ECE/TRANS/WP.29/2006/12
19 December 2005

PROPOSAL FOR SUPPLEMENT 27 TO THE 03 SERIES OF AMENDMENTS
TO REGULATION No. 37

(Filament lamps)

Transmitted by the Working Party on Lighting and Light-Signalling (GRE)

"CATEGORIES P24W, PX24W, PY24W, PR24W, PS24W, PSX24W, PSY24W and PSR24W

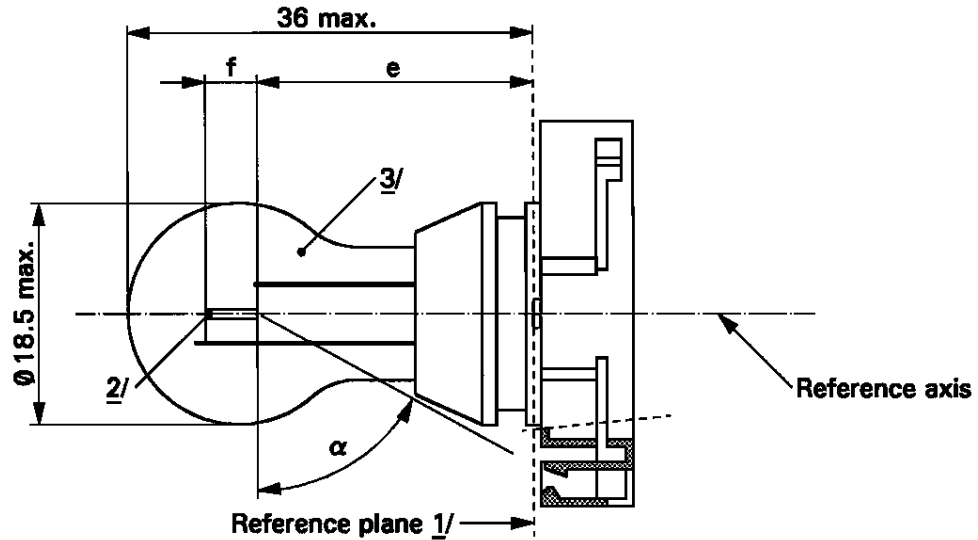
Sheets from P24W/1 to P24W/3, amend to read: (see next pages)

- 1/ The reference plane is defined by the meeting points of the cap-holder fit.
- 2/ No actual filament diameter restrictions apply but the objective is d max. = 1.1 mm.
- 3/ The light emitted from normal production lamps shall be white for categories P24W, PX24W, PS24W and PSX24W; amber for categories PY24W and PSY24W; red for the categories PR24W and PSR24W. (See also note 8/)

FILAMENT LAMP FOR MOTORCYCLES

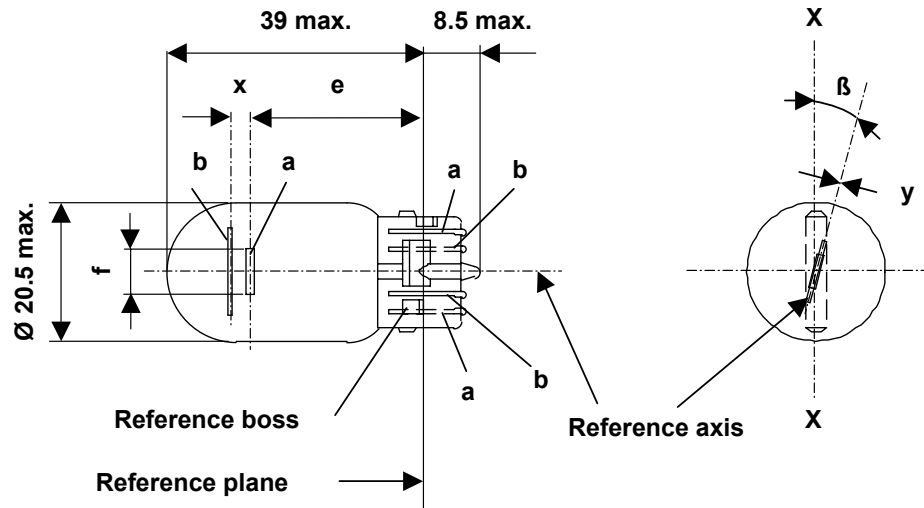
Insert new sheets W15/5W/1 to 3, between sheet W5W/1 and sheet W16W/1, to read: (see next pages).

a= major (high wattage) filament
b= minor (low wattage) filament

Dimensions in mm	Filament lamps of normal production			Standard filament lamp	
	min.	nom.	max.		
e		25.0 <u>1/</u>		25.0 ± 0.3	
f			7.5	7.5 + 0/ - 2	
Lateral deviation <u>2/</u>			<u>1/</u>	0.3 max.	
x <u>3/</u>		2.8 <u>1/</u>		2.8 ± 0.3	
y <u>3/</u>		0.0 <u>1/</u>		0.0 ± 0.3	
β	-15° <u>1/</u>	0°	+15° <u>1/</u>	0° ± 5°	
Cap WZ3x16q in accordance with IEC Publication 60061 (sheet 7004-[...]-1)					
ELECTRICAL AND PHOTOMETRIC CHARACTERISTICS					
Rated values	Volts	12			12
	Watts	15	5	15	5
Test voltage	Volts	13.5			13.5
Objective values	Watts	19.1 max.	6.6 max.	19.1 max.	6.6 max.
	Luminous flux	280 ± 15 %	35 ± 20 %		
Reference luminous flux: 280 lm and 35 lm at approximately 13.5 V

1/ To be checked by means of a "Box-System"; sheets W15/5W/2 and 3.

2/ Maximum lateral deviation of filament centre from two mutually perpendicular planes both containing the reference axis and one containing axis X-X.

3/ "x" and "y" denote the offset of the axis of the minor filament with respect to the axis of the major filament.
